Subject: MHI's Response to US-APWR DCD RAI No. 721-5535 Revision 2 (SPR

09.01.04)

Response to Request for Additional Information No. 721-5535 Revision 2

QUESTION NO.: 09.01.04- 22 Follow Up to RAI 9.1.4-21

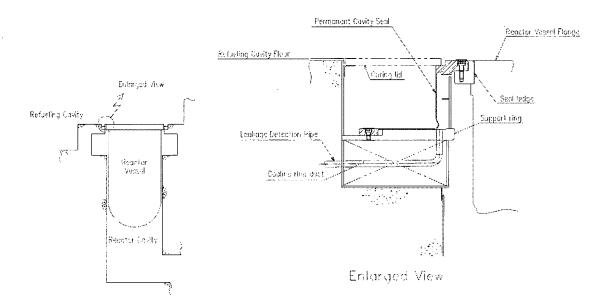
- 1. Descriptive information of the permanent cavity seal (PCS) provided in RAI response 09.01.04-16 and supplemental response 09.01.04-21, in addition to the figure for illustrative purposes, should be added to Tier 2 of the DCD. This information should include:

- a. functional description of the seal
 - b. material and codes/standards used
 - c. justification for how the seal is protected from dropped loads
 - d. description of the leak detection system

4. The response to RAI 09.01.04-21 provided a drawing that included the leakage detection design. From the information contained in the drawing and description in the RAI response, it was not clear to the staff that all of the expected leakage would be directed into the leakage detection pipe. Additional information regarding the leakage detection design is needed in the DCD, including assurance that all leakage from the PCS will enter the leakage detection pipe.

MHI will provide additional information regarding the leakage detection design in Tier 2 of DCD Chapter 9 Section 9.1.4.2.1. See the fourth paragraph in the new Section 9.1.4.2.1.13 "Permanent Cavity Seal (PCS)" to be added.

Leakage detection systems are utilized for the PCS. Two leakage detection pipes are installed under the ring-shaped PCS directly opposite each other across the reactor vessel. Wherever around the seal leakage from the PCS should occur, the leakage water flows and accumulates into an annular space between a vertical cylindrical plate, which is attached to support ring, and the PCS, and eventually flows into one or both of the detection pipes. Once water flows into the leakage detector via the leakage detection pipe, the leak detection system provides an alarm signal to alert operators in the MCR and in the vicinity of the fuel handling system that an abnormal water level condition exists in the refueling cavity.

The refueling cavity water High and Low level is monitored by a refueling cavity water level indicator and an alarm, which are shown as "LIA 011-N" in Tier 2 of the DCD Rev. 2 Figure 5.1-2 (Sheet 3 of 3).
